ADC PARKS & GREENSPACE ARBORICULTURE

PLANNING APPLICATION: Y/12/15/PL

ADDRESS: The Old Coal Yard North End Road Yapton BN18 0DN

BRIEF DESCRIPTION: Construction of 4No. houses with associated landscaping & parking

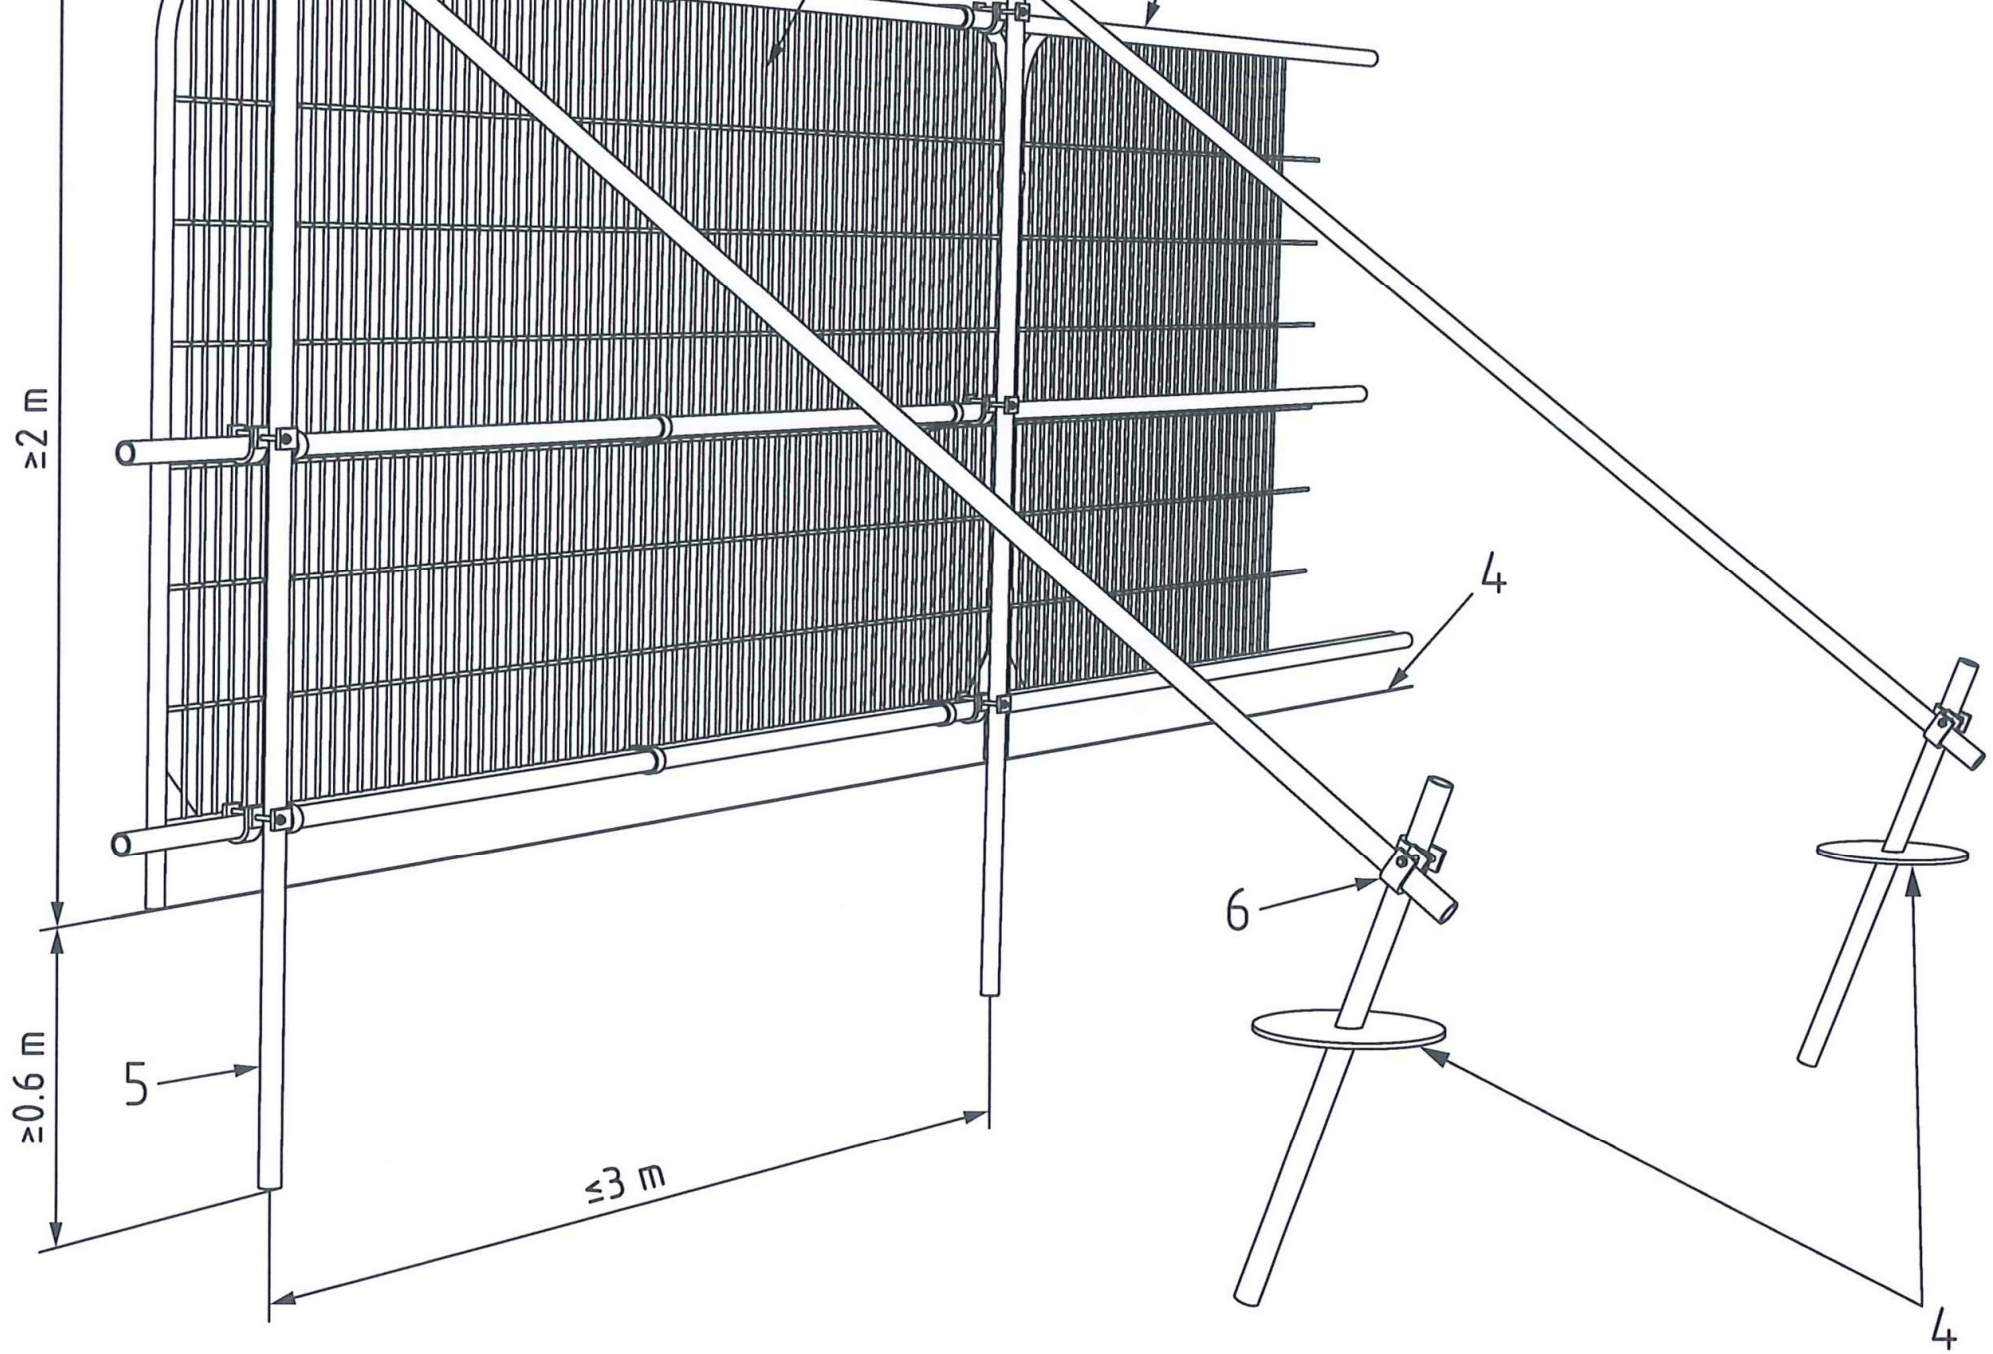
- Although not ideal (due to the size of the area to be surfaced) for the proposed mitigation offered for RPA, main stem and canopy of **T8**, the applicant has correctly cited the differing techniques and materials required. The applicant has also cited the use of a '*watering system is to be designed to either capture rain water and direct it onto the soil below the road deck or for the roadway to be permeable. These systems must take into account that if the surface is to be subjected to de-icing salt, an impermeable barrier or filtration system will be required to prevent contamination of the rooting area*'. Considering the large area of **T8** RPA that is proposed to be used as a driveway (using a hard surface), the use of a watering system and an impermeable barrier/filtration system will be an important aspect of preventing leaching of the soil and keeping **T8** in a healthy condition.

- The applicant must work to specification established in the Tree protection plan (especially when completing the works and mitigation affecting **T8**).
- If any roots are discovered over 25 mm when excavating (for the fence posts along the southern boundary), they are not severed. If the applicant wishes to sever these roots, then ADC arboriculturist must be informed and allowed to supervise any operations.
